Access Compliance Report Public Rights-of-Way (Curb Ramps)

Main Street: GOSSAMER_PL Cross Street: FLORA_CT Location: SW

ADA ID: RPAT211101102227 Ramp Type: Type 4 - Parallel Initial Pass/Fail: Fail Overall Compliance: No Severity Score: 2

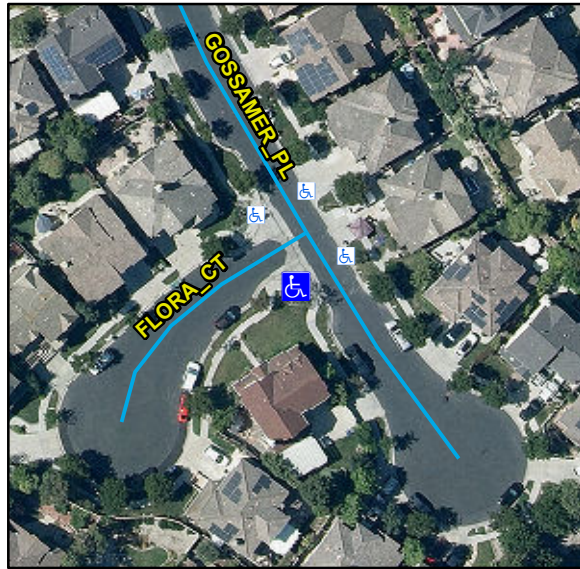
Compliance	Description	Data	Compliance	Description	Data
N/A	Ramp Length LT (in)	108	N/A	Ramp Length RT (in)	107
Yes	Ramp Width LT (in)	54	Yes	Ramp Width RT (in)	53
Yes	Ramp Run Slope LT (%)	5.7	Yes	Ramp Run Slope RT (%)	4.8
No	Ramp Cross Slope LT (%)	3.5	Yes	Ramp Cross Slope RT (%)	1.9
N/A	Landing Present	N/A	N/A	DWS Provided	N/A
N/A	Landing Length (in)	N/A	N/A	DWS Contrast	N/A
N/A	Landing Width (in)	N/A	N/A	DWS Length (in)	N/A
N/A	Landing Run Slope (%)	N/A	N/A	DWS Full Width	N/A
N/A	Landing Cross Slope (%)	N/A		DWS Offset Type	N/A
N/A	Landing Movement Obstructed?	N/A	N/A	DWS Offset Left (in)	N/A
	Landing Movement Type	N/A	N/A	DWS Offset Right (in)	N/A
N/A	Landing Shared	N/A			
N/A	Clear Space	Yes			
N/A	Clear Space To Crosswalk (in)	N/A			
N/A	Marked Crosswalk 1	No	N/A	Marked Crosswalk 2	No
	Crossing 1 Direction	E		Crossing 2 Direction	N
N/A	Marked Crosswalk 1 Width (in)	N/A		Marked Crosswalk 2 Width (in)	N/A

Remove & Replace Curb Ramp With Two New Directional Ramps or Equivalent.
